TECHNICAL NOTE

Job Name: Kings Meadow View, Reading

Note No: TN003

Subject: **Transport Response to Consultee Responses by Reading Borough Council**
Transport Development Control and Active Travel England

SWEPT PATH ANALYSIS - 12m RIGID

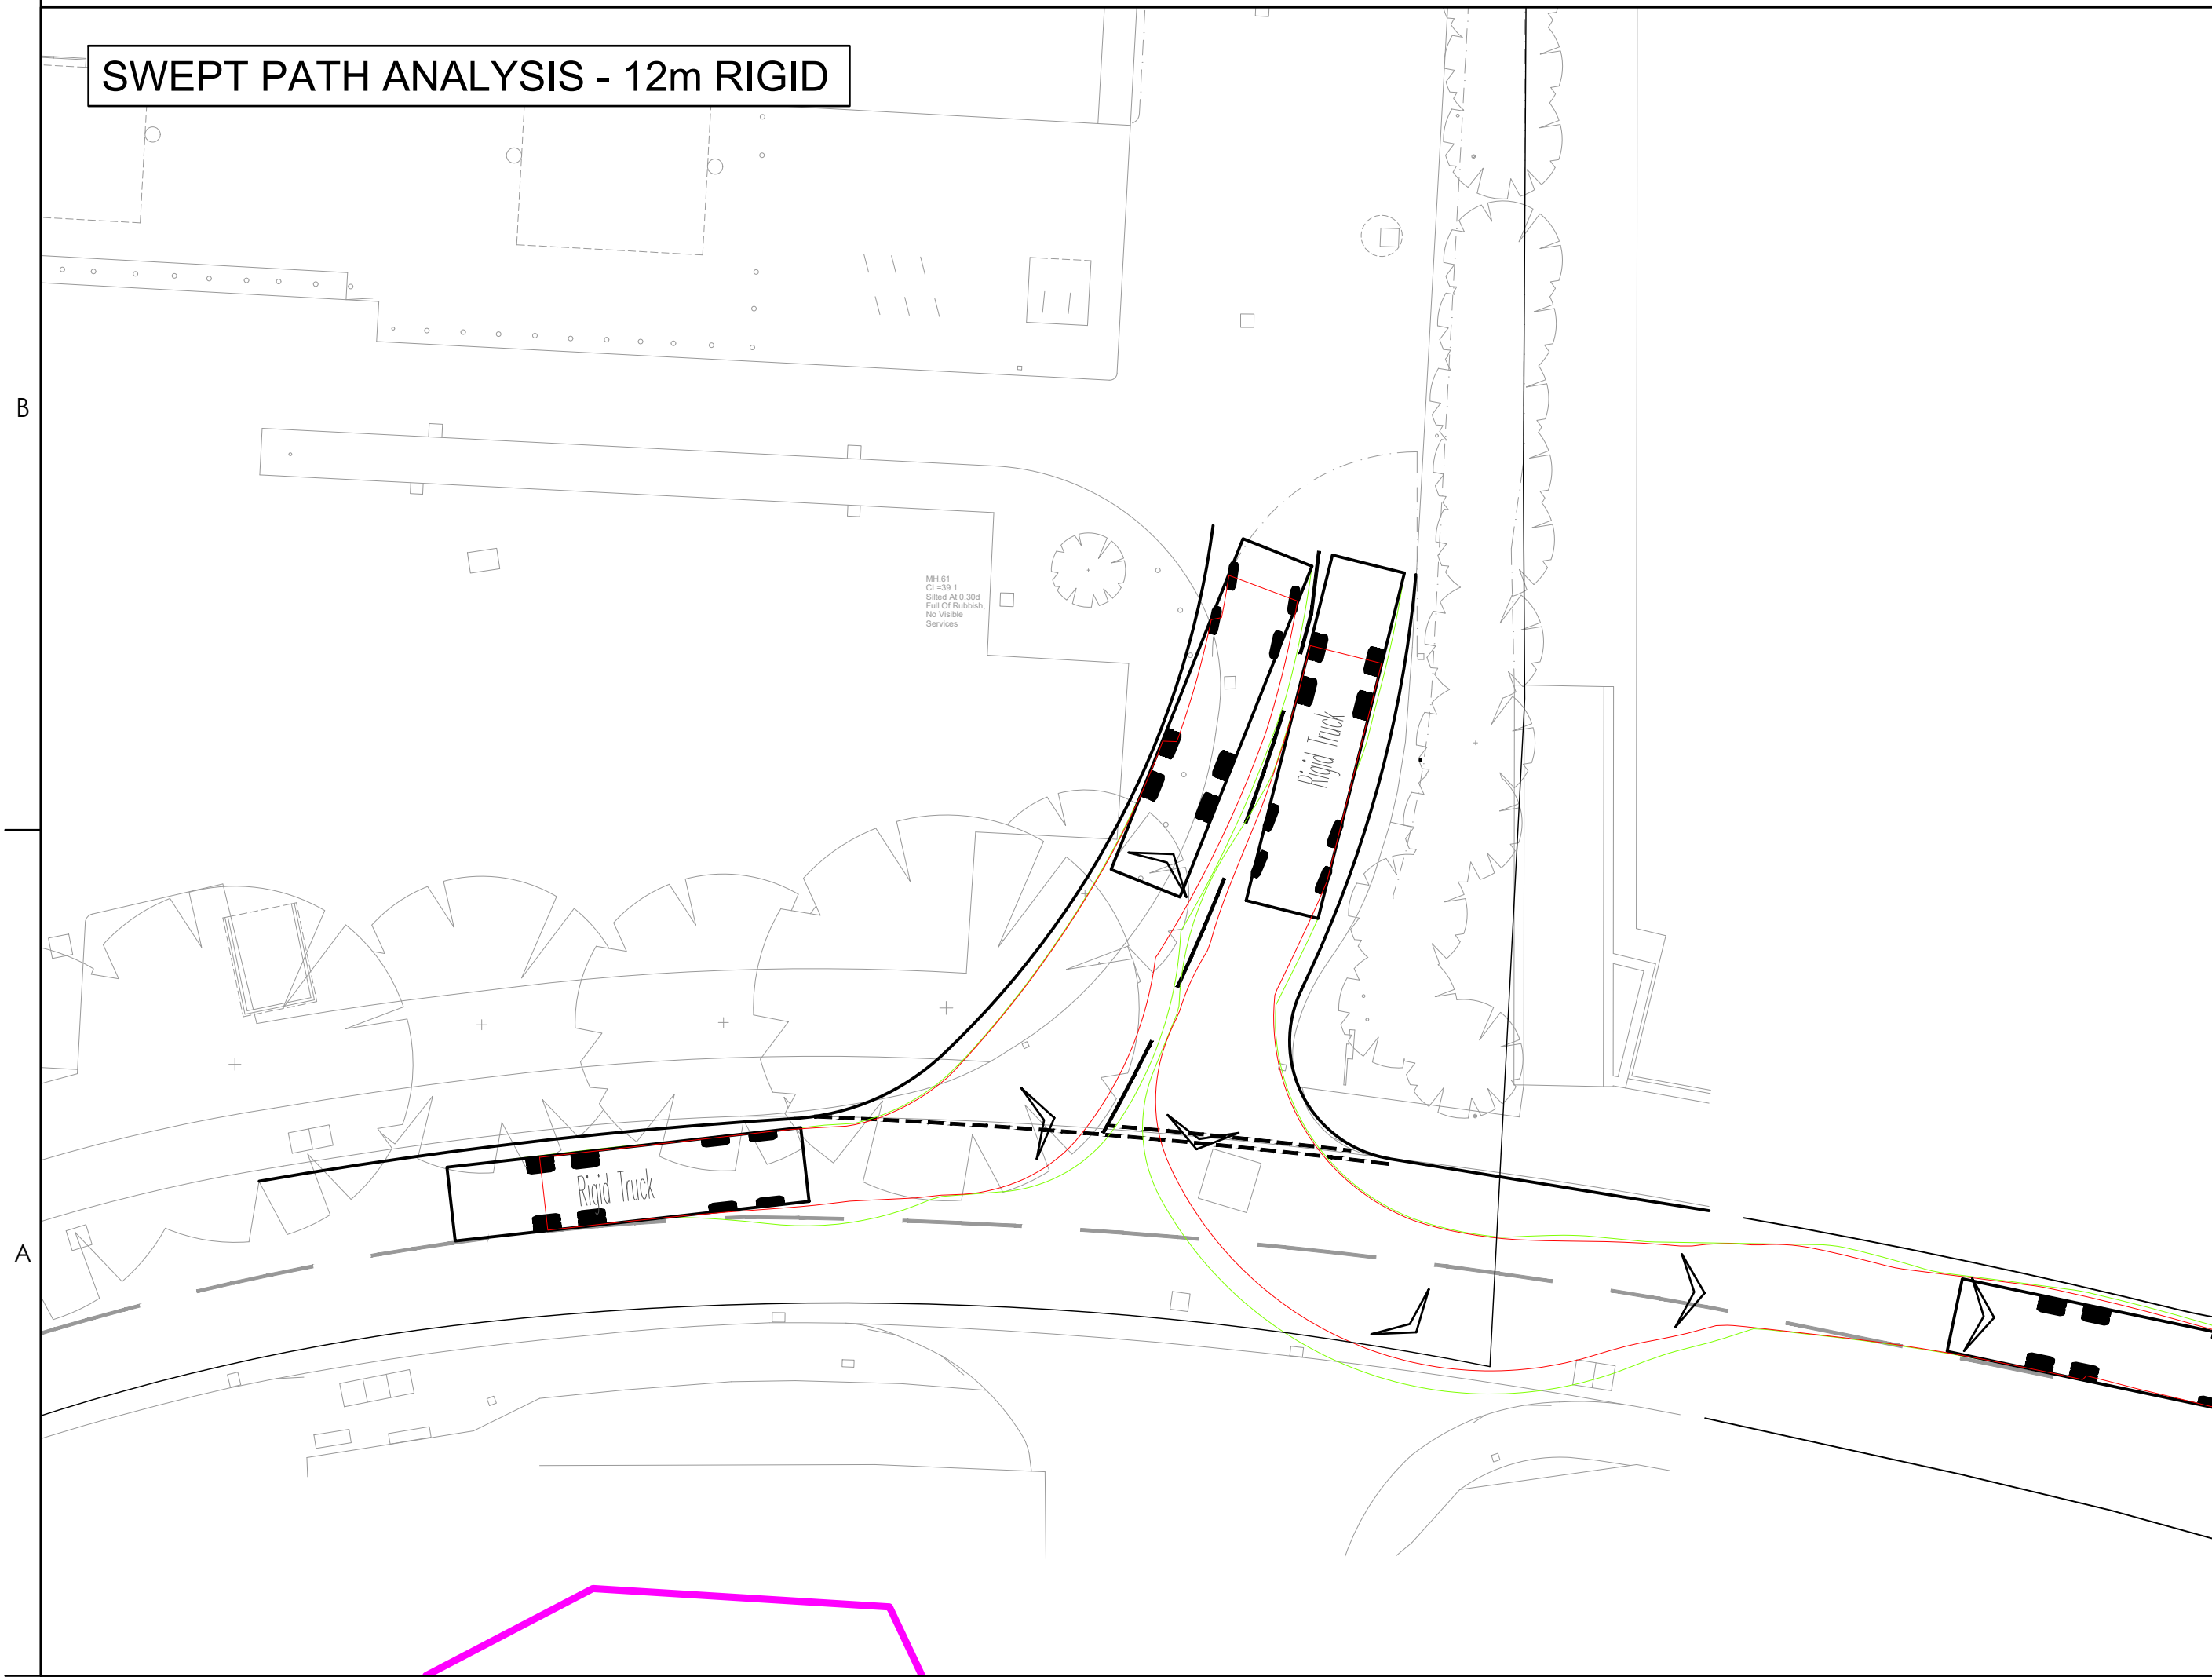
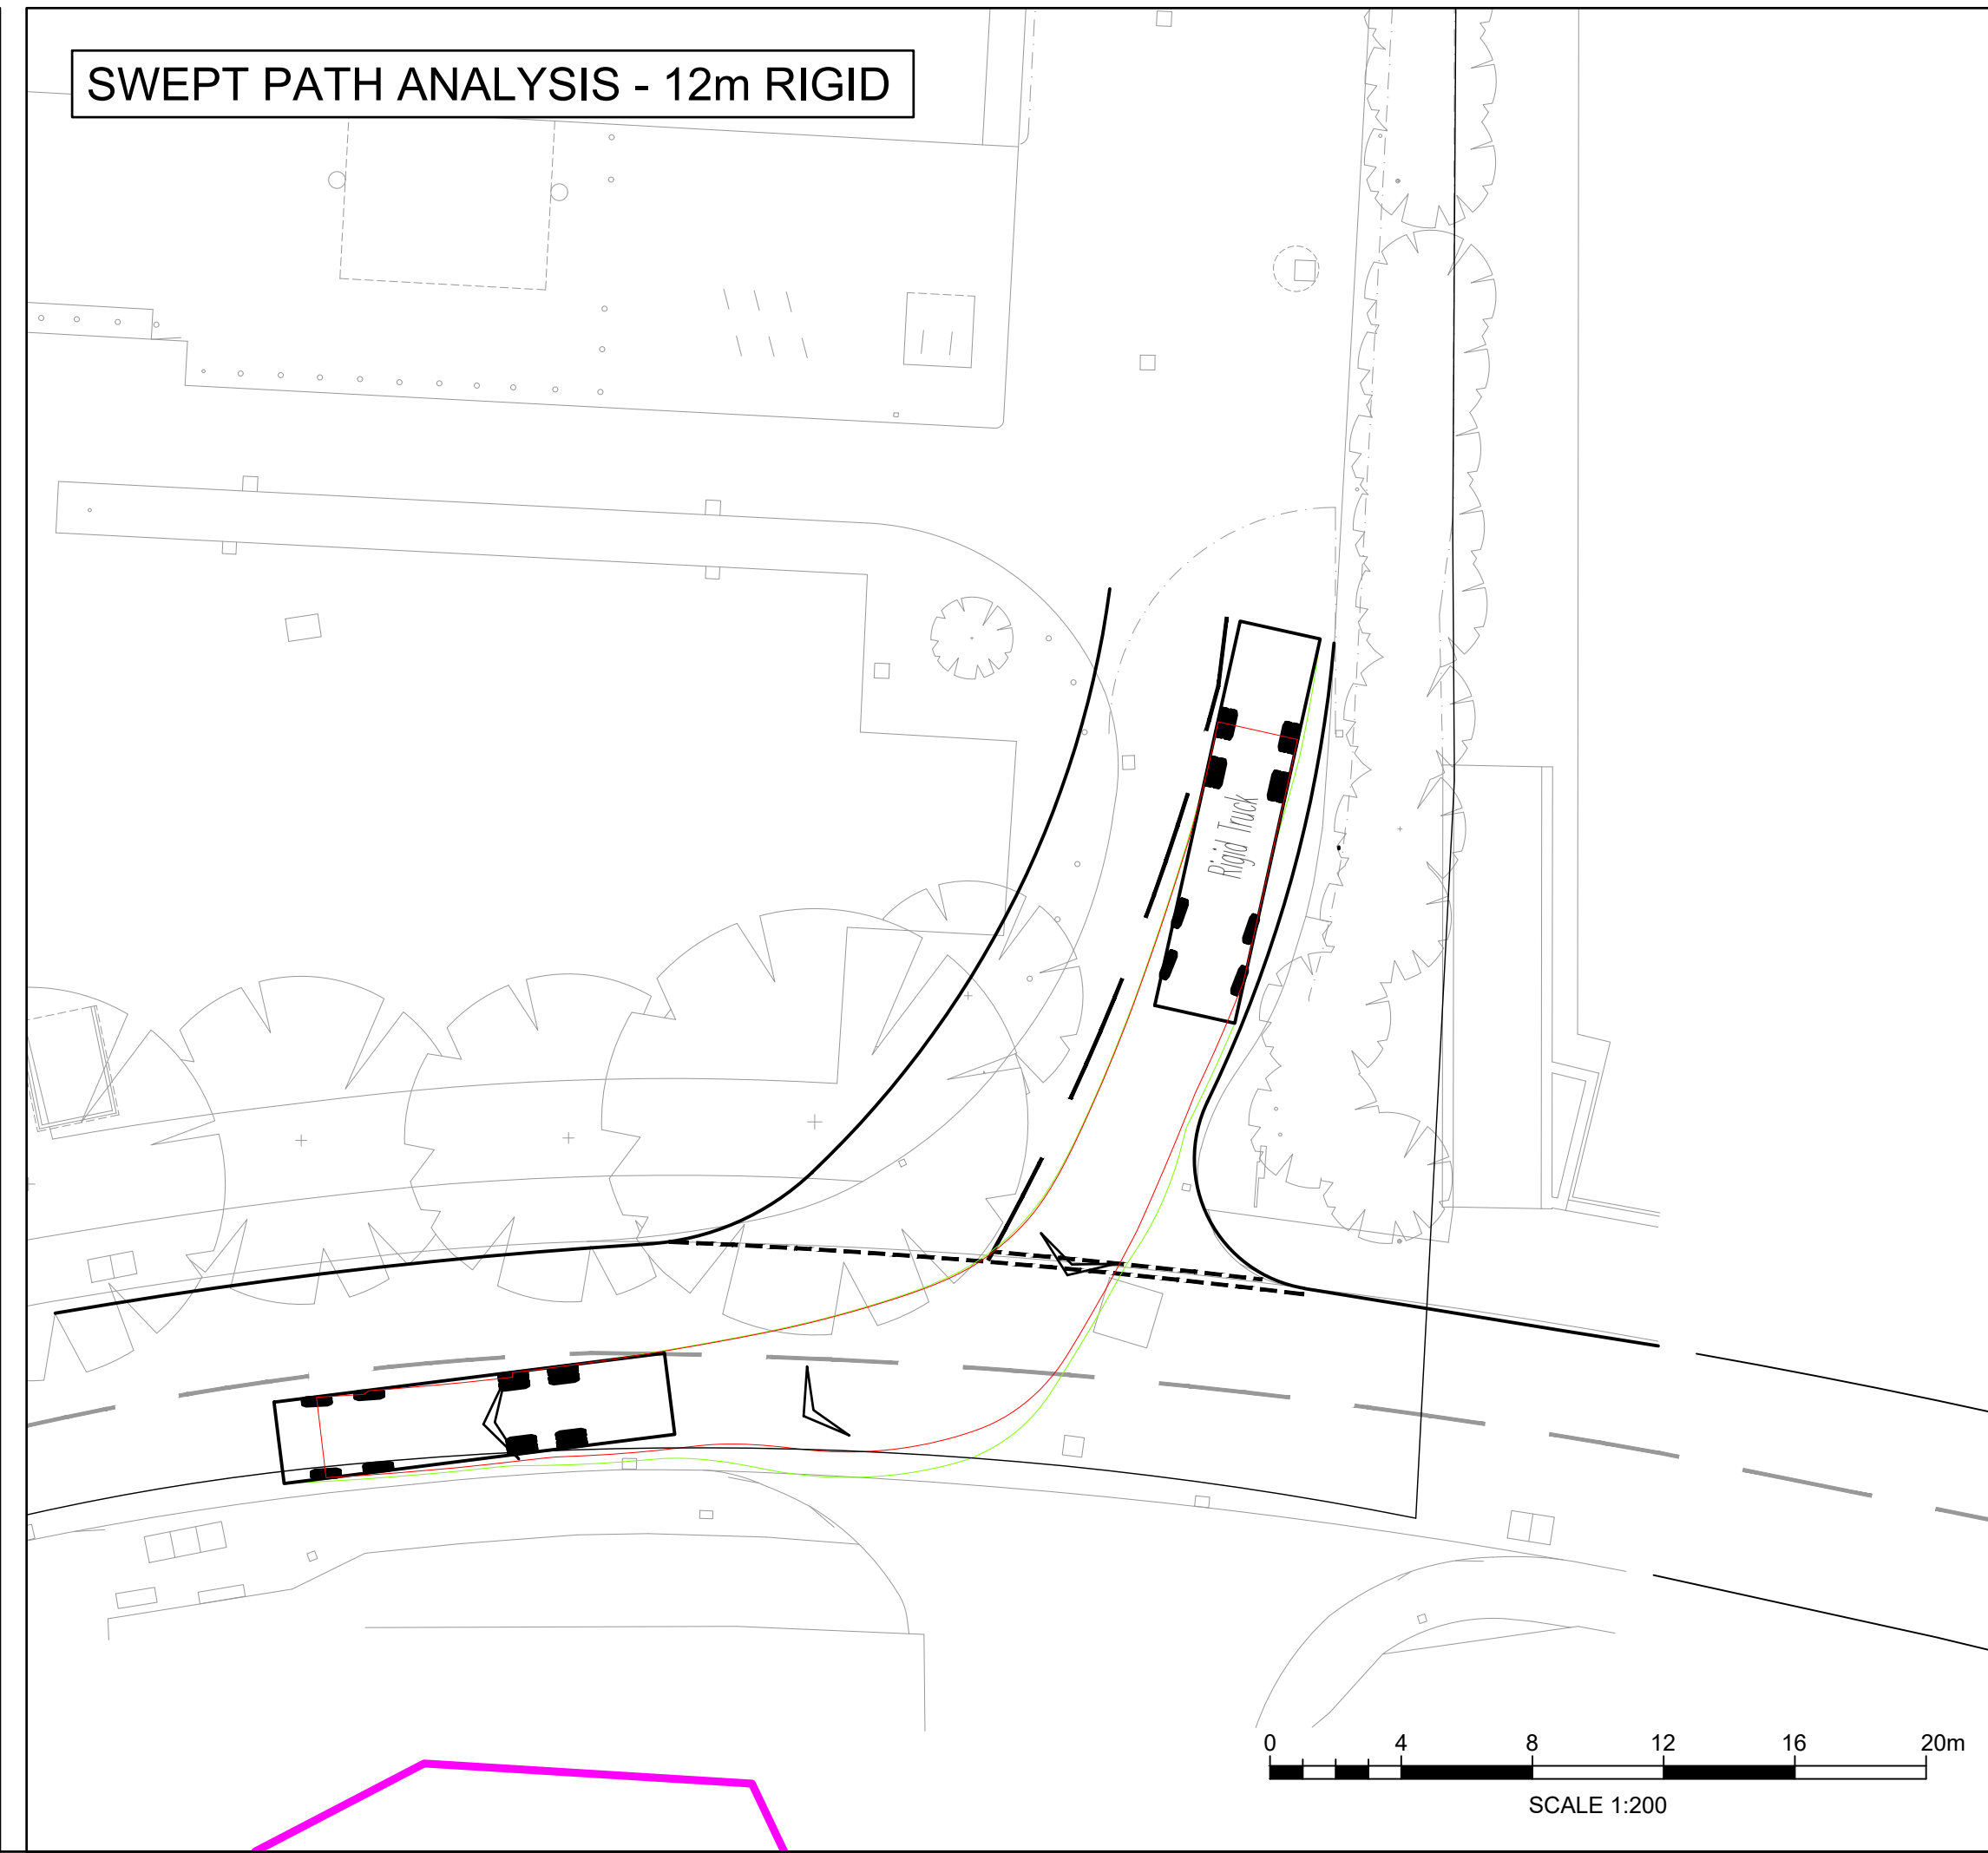
The Transport Assessment (paras. 6.3.8–6.3.9) notes that, when required, servicing vehicles may enter the public realm to service the southern row of blocks, under management by the Estate Management Team. Nonetheless, the information provided within the Design Code, parameter plans and the supporting Waste Strategy document is insufficient to establish how servicing access will operate across the full extent of the residential development

Swept path analysis of a refuse collection vehicle was included in Appendix D of the Transport Assessment. Servicing bays are proposed on the southern edge of the servicing access route. The servicing route will not be available for general traffic. The Management Team will control and manage this. This will be set out in the Delivery & Servicing Management Plan, which will be submitted at the appropriate reserved matters stage, providing further clarification on this matter
